**GENOA CHARTER TOWNSHIP
PLANNING COMMISSION PUBLIC HEARING
SEPTEMBER 9, 2024
MONDAY
6:30 P.M.
AGENDA**

Re: Community Bible Church Parking Lot Expansion

Attention:	Amy Ruthig, Planning Director
Subject:	Community Bible Church – Site Plan Review #2
Location:	7372 Grand River Avenue – southwest corner of Grand River and Harte Drive
Zoning:	GCD General Commercial District

**Re: Community Bible Church Parking Lot
Site Plan Review No. 2**

SITE PLAN

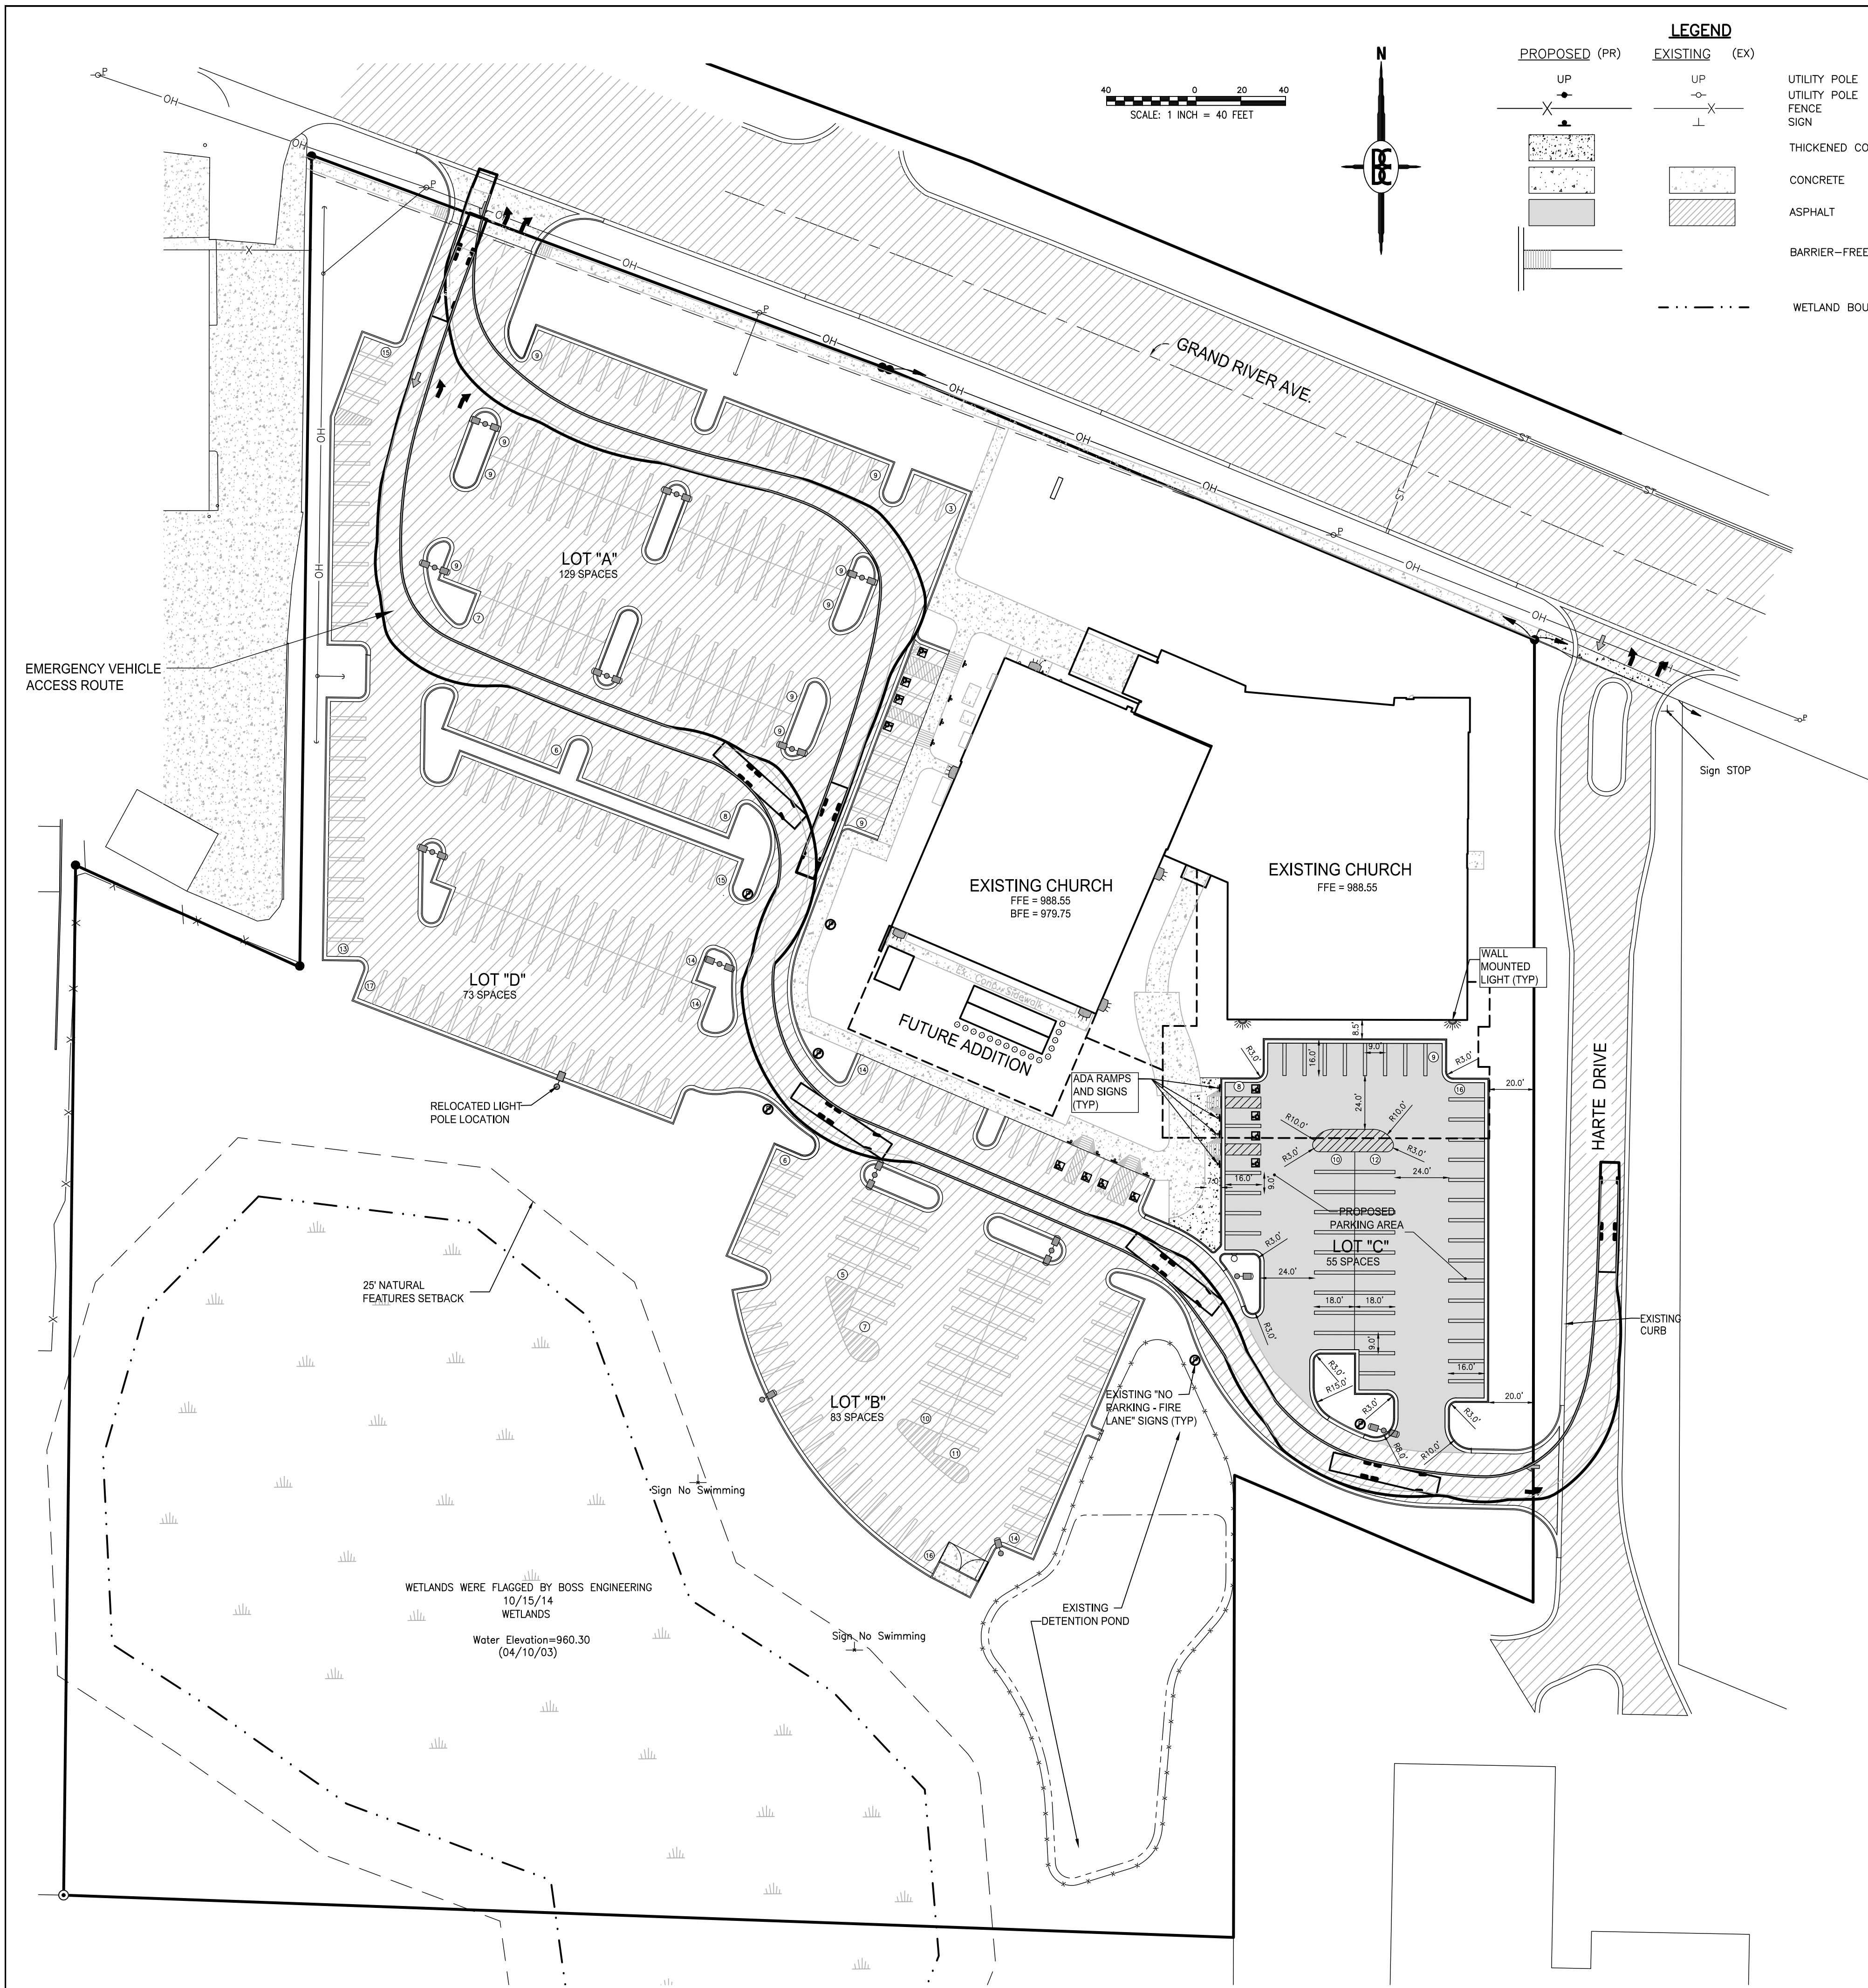
1. The proposed parking lot has been shifted 10' westerly to be at the 20' setback line. Multiple parking spaces were lost in making this shift. In an effort to preserve/regain parking spaces back, the integral sidewalk at the north was replaced with standard curbing. This regained some space and allowed the parking lot to shift northerly and regain some spaces on the southern side of the parking lot. The parking lot still is net negative 1 parking space.

The revised site plan provides the required 20-foot setback along Harte Drive.

Additionally, calculations on Sheet C3 identify an impervious surface ratio of 34.5%, which is within the 75% maximum allowed.

TITLE: LANDSCAPE PLAN

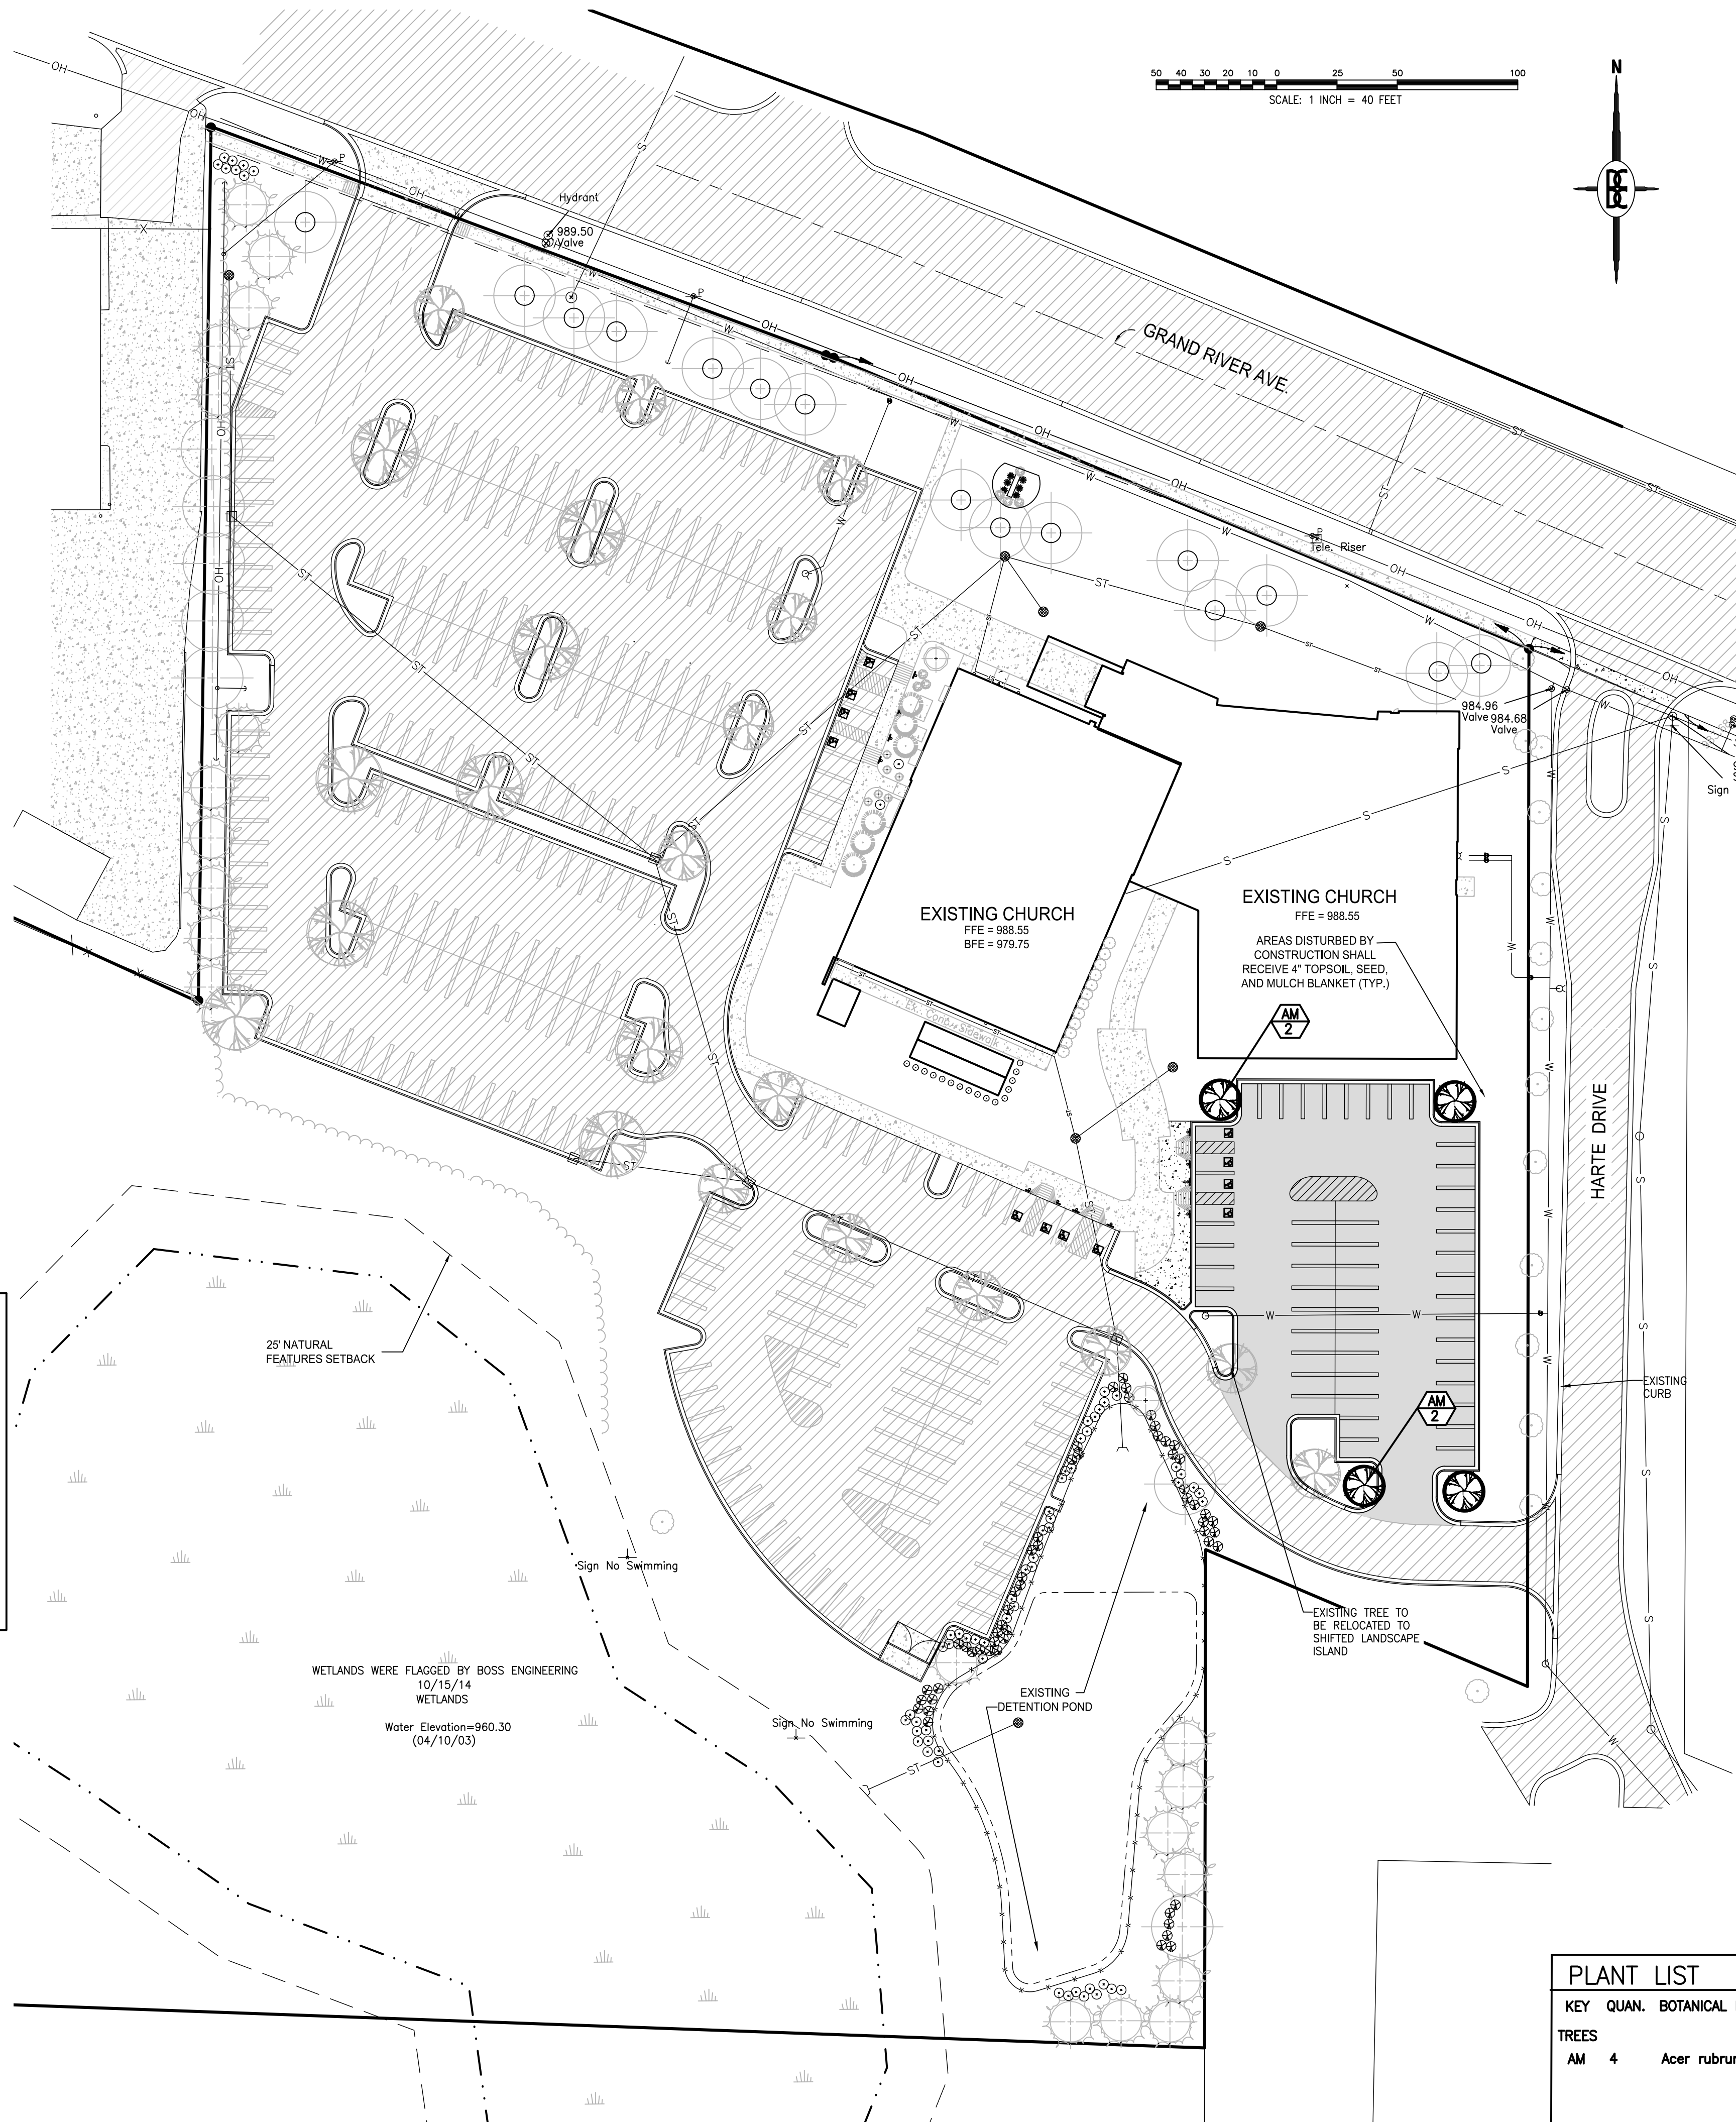
4. Discussion at the Planning Commission entailed favoring providing a greenbelt to match requirements of Zone 'C', and thus no berm/wall or landscaping is needed. The west side of Harte Drive is established with a mature tree row.

- 5. Landscaping.** At the previous meeting, the Planning Commission requested that the applicant provide a Buffer Zone C along Harte Drive. Accordingly, the landscape plan has been reviewed for compliance as follows:
